Access Compliance Report

Public Rights-of-Way

(Curb Ramps)

Intersection ID: 12267	Main Street: CENTRAL_AV	Cross Street: LOUISE_AV	Location: N
ADA ID: 016EC4E67052	Ramp Type: Para	Initial Pass/Fail: Fail	Overall Compliance: No
Codes/Mitigation Info/Possible Solution		Field Measurements/Component Compliance

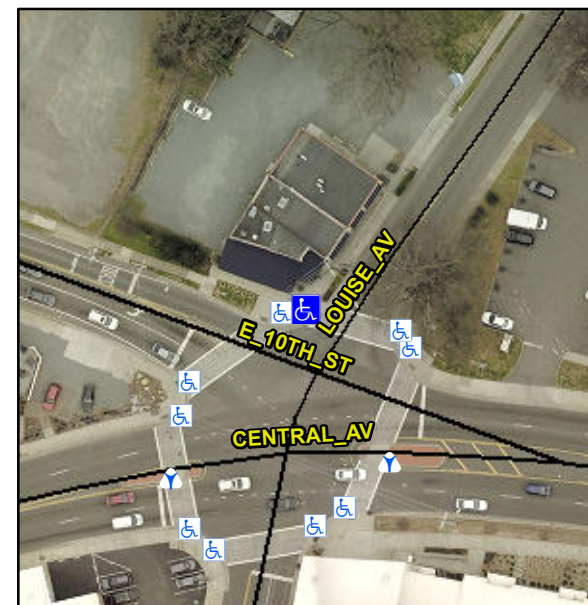
R304.5.3, R304.3.2

Compliance	Description	Data	Compliance	Description	Data
N/A	Ramp Length LT (in)	50.5	N/A	Ramp Length RT (in)	66.0
Yes	Ramp Width LT (in)	72.0	Yes	Ramp Width RT (in)	71.0
Yes	Ramp Slope LT (%)	5.0	No	Ramp Slope RT (%)	8.6
No	Ramp XSlope LT (%)	2.9	No	Ramp XSlope RT (%)	4.9
N/A	Landing Length (in)	N/A	N/A	DWS Provided?	N/A
N/A	Landing Width (in)	N/A	N/A	DWS Contrast?	N/A
N/A	Landing Slope (%)	N/A	N/A	DWS Length (in)	N/A
N/A	Landing X Slope (%)	N/A	N/A	DWS Full Width?	N/A
N/A	Landing Curb? (Y/N)	N/A	N/A	DWS Offset (in)	N/A
N/A	Shared Landing?	N/A			
N/A	Gutter Ponding?	N/A	N/A	Gutter Slope (%)	N/A
N/A	Gutter Lip Ht (in)	N/A	N/A	Gutter X Slope (%)	N/A
N/A	Painted X Walk1?	Yes	N/A	Painted X Walk2?	N/A
	X Walk 1 Direction	To SE		X Walk 2 Direction	N/A
N/A	X Walk 1 Width (in)	144.0	N/A	X Walk 2 Width (in)	N/A
	X Walk 1 Slope (%)	0.4		X Walk 2 Slope (%)	N/A
	X Walk 1 X Slope (%)	5.2		X Walk 2 X Slope (%)	N/A
N/A	Ramp inside XWalk1?	Yes	N/A	Ramp inside XWalk2?	N/A

Remove & Replace Entire Ramp.
